# Darden Clean Energy Project (23-OPT-02)

## CEC Data Request Response Set #1

**February 2024**

**Figure 1 DR WS-3 Typical BESS Fire Protection Layout**

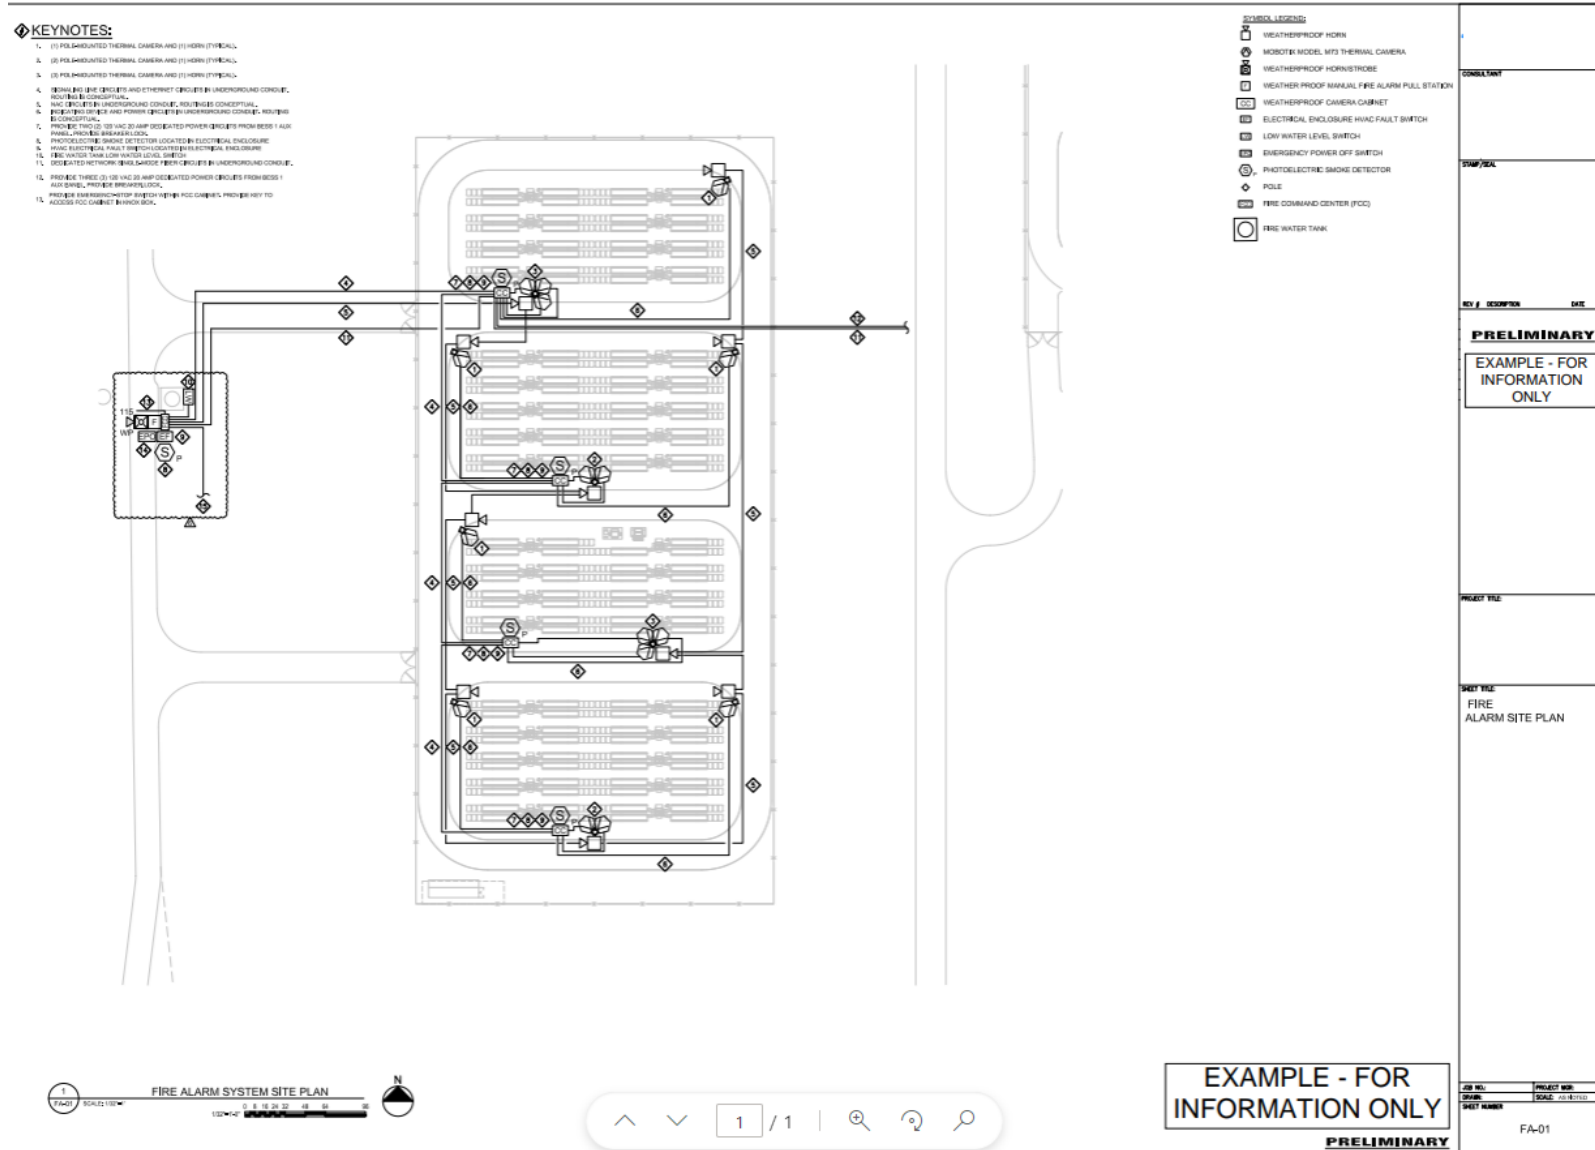
**DR WS-3:** Please provide schematic engineering drawings detailing the location and type of all proposed fire detection, fire suppression, water supply and leak detection equipment for the BESS and Green Hydrogen portions of the project, and the location of hydrants, post indicator valves, and monitors for the fire water loop. Please provide this information for all proposed alternative

locations or state that these systems will be the same. Additionally, please provide how any explosion hazards would be mitigated at the Green Hydrogen and BESS portions of the project.

The fire detection drawings for the Project BESS will be developed as detailed engineering continues. The BESS yard will have thermal detection cameras installed externally on battery containers and will be strategically placed in optimal locations to detect fires. These cameras will be remotely monitored 24 hours a day. There will be up to four emergency 15,000-gallon water tanks for the Project, based on final layout. A typical BESS fire protection layout is provided in Figure 1 below and is discussed in the response to DR HAZ-7. The final number and location of water tanks for emergency use will be determined in accordance with California Fire Code and be reviewed/approved by the local or State Fire Marshal.

The BESS equipment selected for the Project will be tested pursuant to UL 9540A standards, and the Project will be designed and built pursuant to UL and NFPA codes. The BESS equipment to be used will be tested to demonstrate that they do not require built-in smoke, gas, or fire detection or suppression devices.

The BESS equipment will be designed to minimize the risk of an over-pressure event and deflagration through the use of over-pressure vents and a sparker system. These safety features will be tested pursuant to UL 9540A standards to demonstrate their effectiveness in preventing deflagration in a large-scale fire.
